Addendum #2

Invitation to Tender 2024-23

**General Contractor services for school addition at
ÉÉC Saint-Michel, 29 Meadowvale Rd, Scarborough**

**MECHANICAL & ELECTRICAL ADDENDUM #1
ÉÉC SAINT-MICHEL – CLASSROOM ADDITION
29 MEADOWVALE ROAD, SCARBOROUGH, ONTARIO. M1C 1R7
APRIL 24, 2024**

DRAWING TITLE:
CONSTRUCTION & TREE
PRESERVATION & HOARDING PLAN

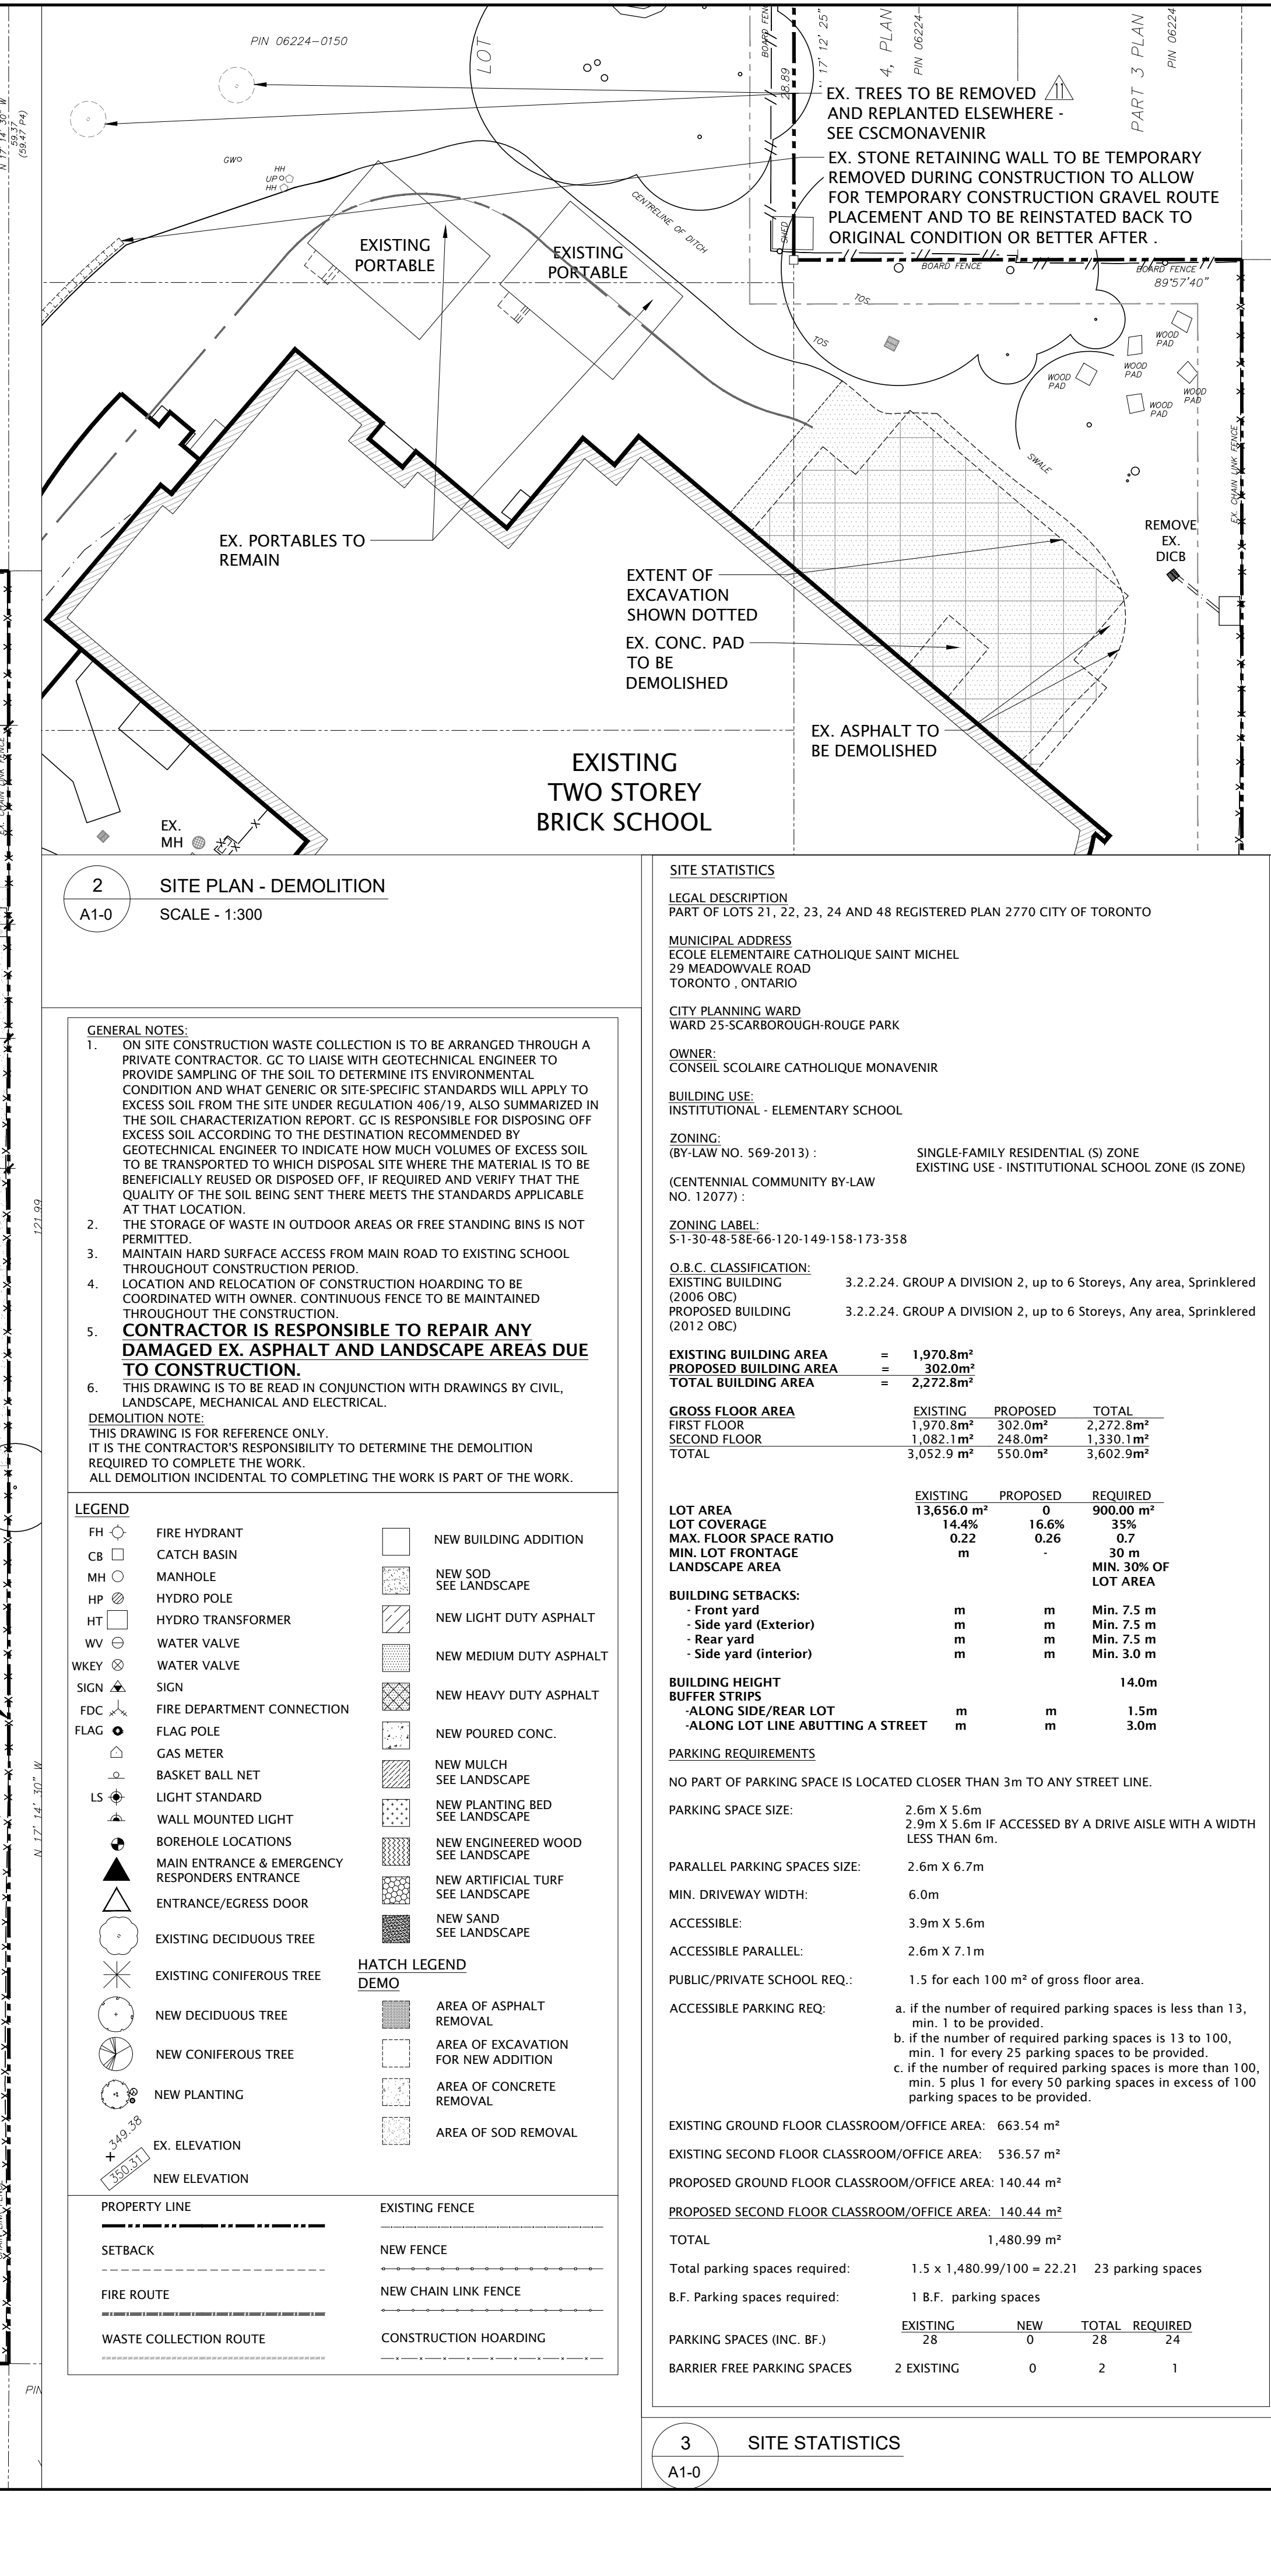
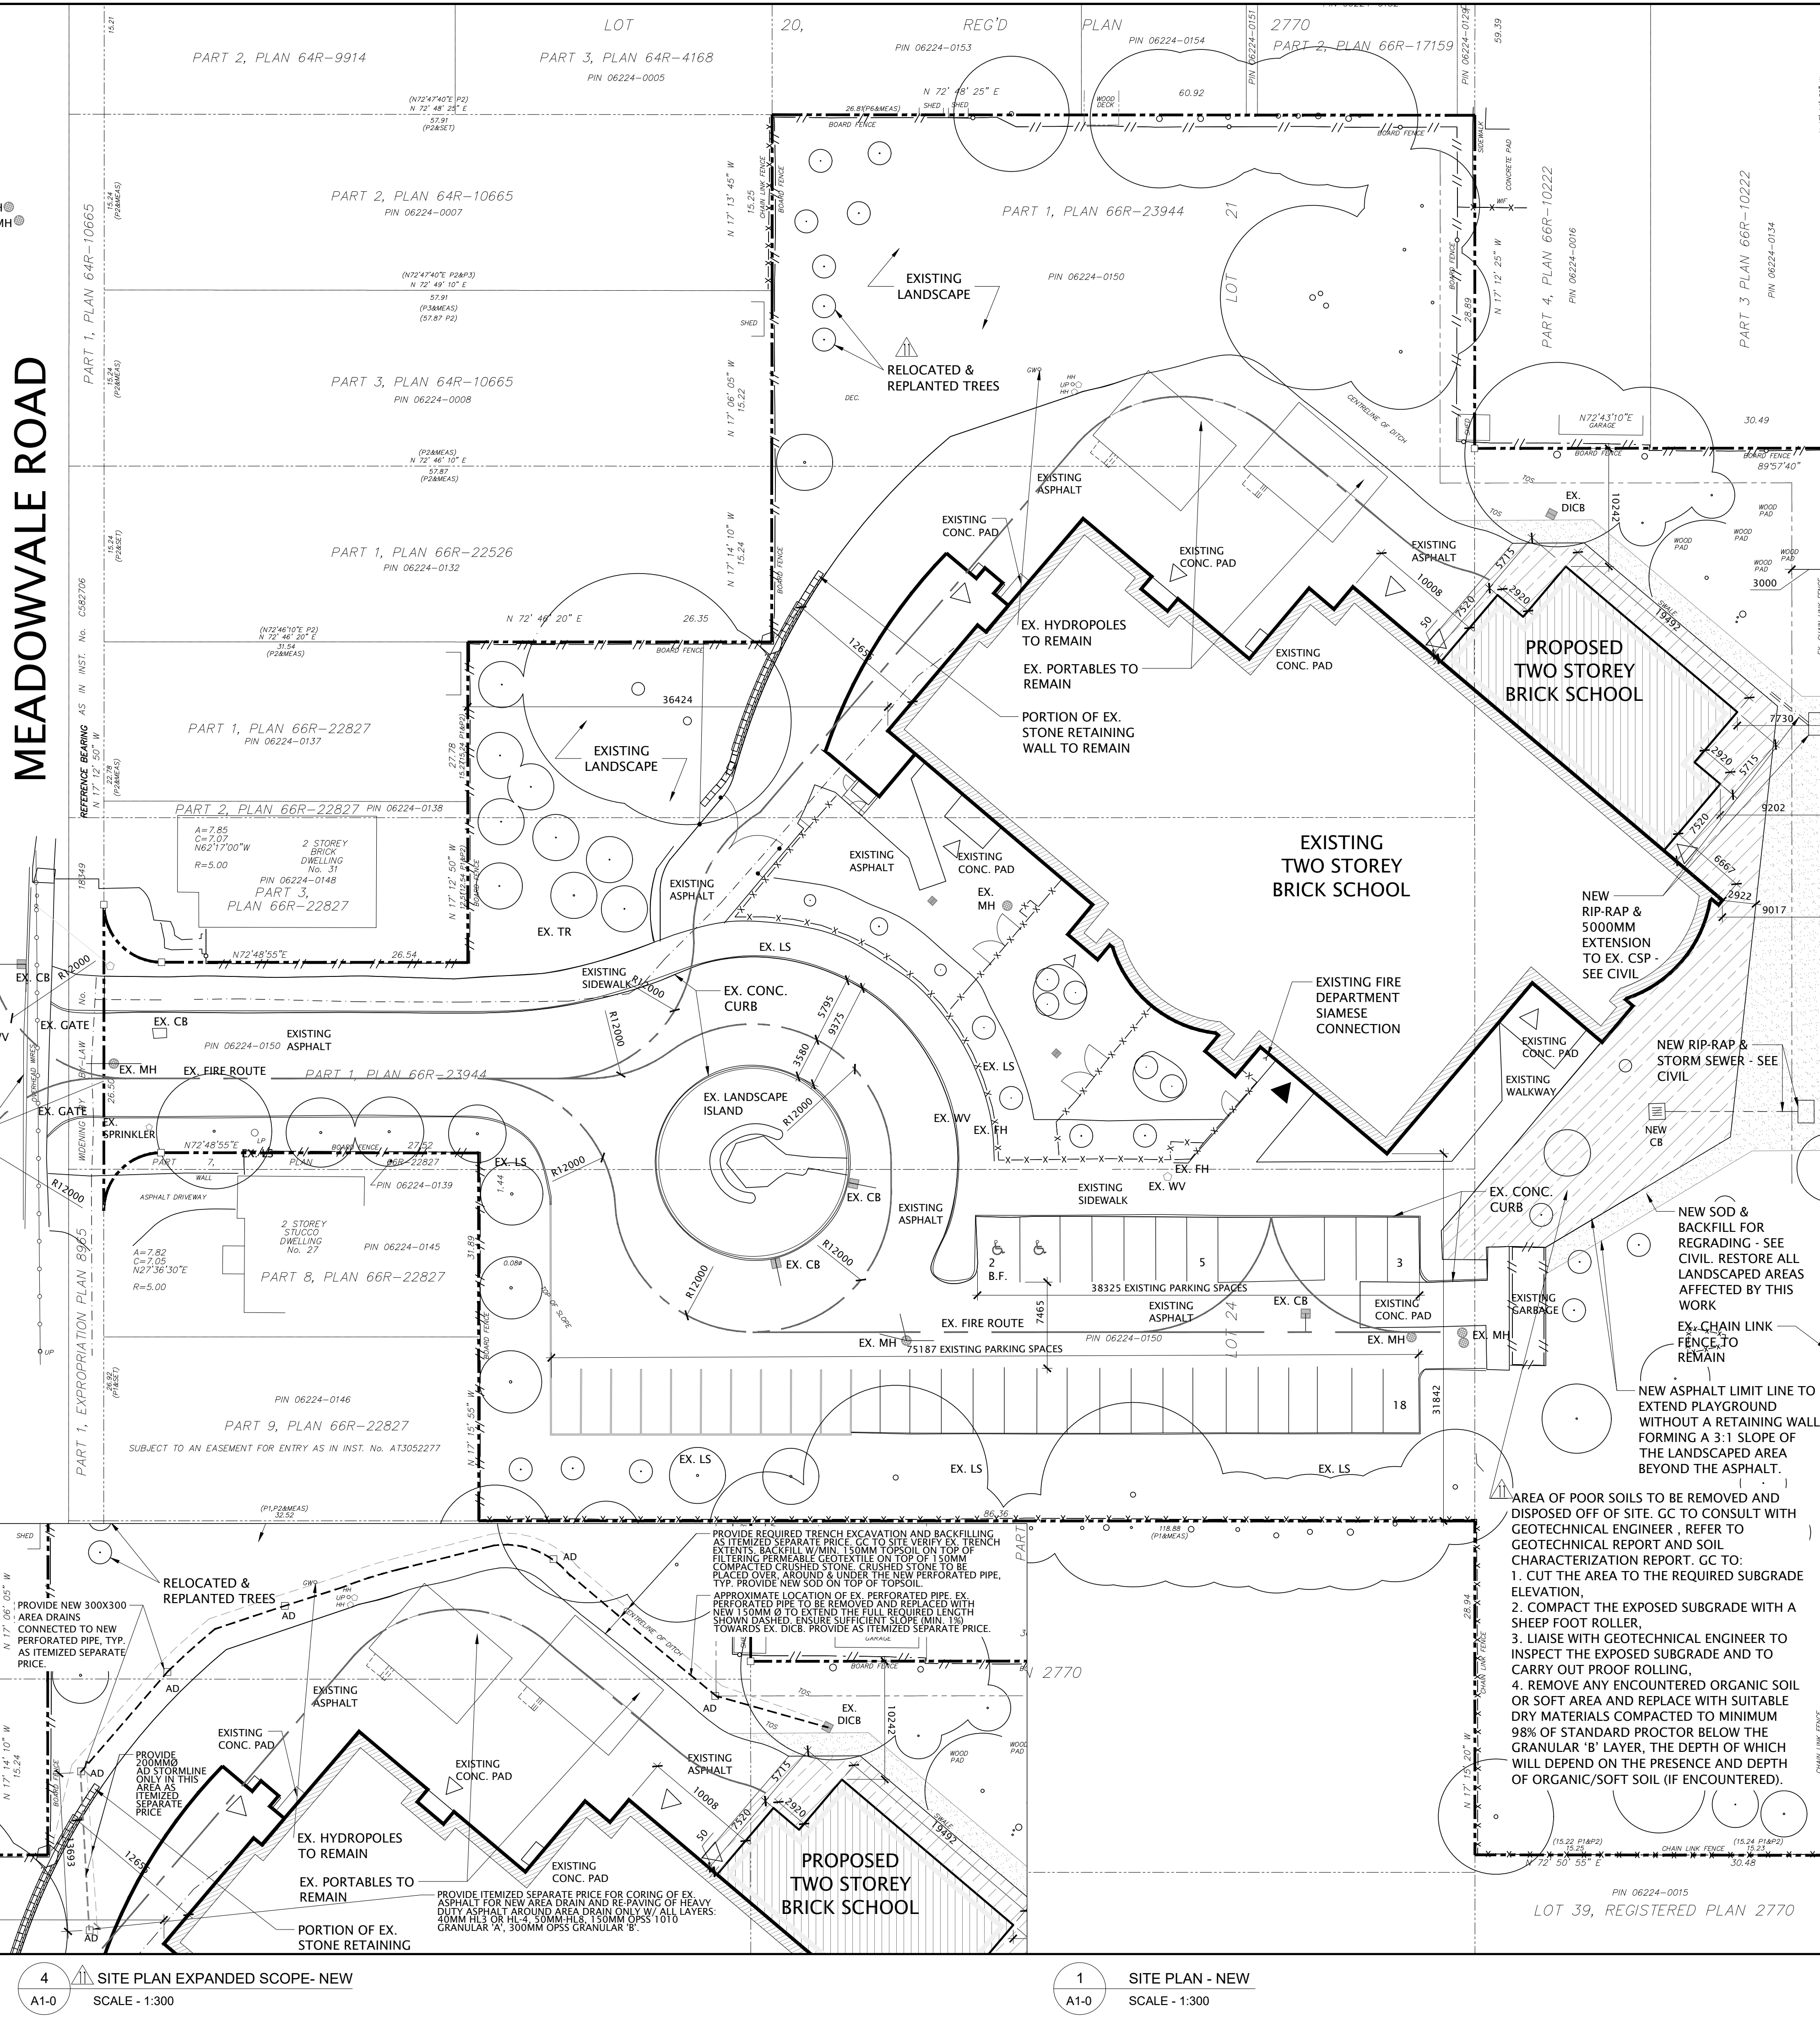
Question 2: Are details for the type 3 hoarding noted on A1-1 able to be provided for reference?

Answer 2: Details for hoarding type 3 have been incorporated into drawing A1-1 R3 attached and re-issued.
